5.2.5. Required Regulatory Support and Coordination

Annex 5.5: Revised Capacity Analysis of TDMA MSS Systems

Figure 1: Motorola Iridium Antenna Beam Pattern

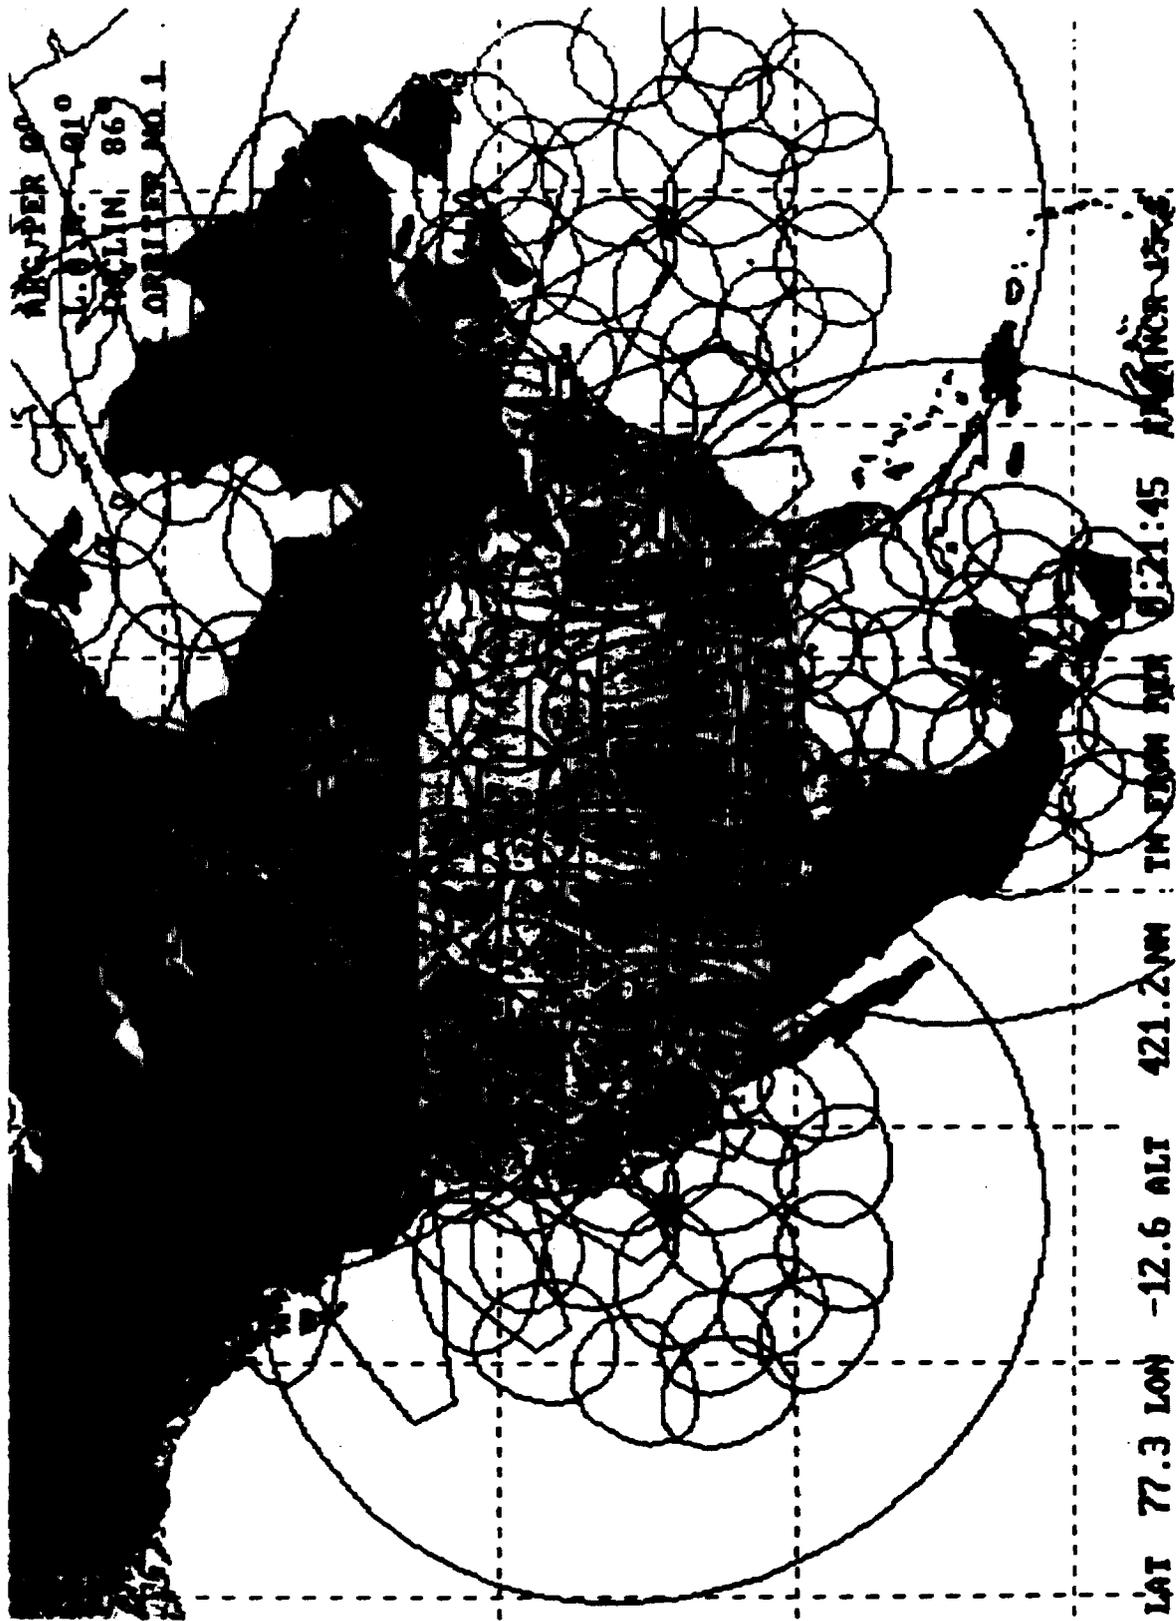
An appreciation for the complexity of this problem can best be understood with a picture of the Iridium beam patterns, which is given in figure 1. Although it shows four satellites, for clarity, this figure depicts the outer ring of beams for only one satellite (at the top of the figure). Each of the other three satellites also have these elongated beams around their edges. As described above, many of the beams overlap not only their immediate neighbor, but also those one concentric ring away. In addition, the elongated outer ring beams stretch all the way past directly under the adjacent satellite. Choosing one of these in the left center of the figure, for example, it is easy to see that it overlaps nine other beams (allowing a minimum frequency reuse of 10) even with the edge beams of its neighbor satellite turned off.

In section 5, Motorola analyzed the Iridium capacity on the assumption that there were 59 satellite beams over CONUS. Counting the beams shown in figure 1 shows this to be incorrect. The actual number at any given time of the day will vary slightly as the constellation of satellites moves. At some times, one satellite might be directly over the center of the continental US. Given the overall area of the satellite footprint, however, adjacent satellites would not be in view at that time. Another scenario (that shown in figure 1) is when several satellites each are partly in view of CONUS. Due to the low altitude of the satellites, they move very quickly; these scenarios and the number of beams over CONUS can change on the order of minutes. At some optimal time, it may be possible that Iridium has 59 beams over CONUS, but the average and minimum values are clearly smaller than this. At the time depicted in figure 1, about 49 beams can be counted. Whether capacity should be calculated with minimum values (so that user calls aren't dropped as the satellites move and capacity decreases) or the average value is debatable. But clearly, a value as high as 59 gives a misleading capacity. If it were corrected to 49 beams, the capacity would decrease by 15%. For the purposes of this analysis, however, we will use Motorola's value of 59 beams.
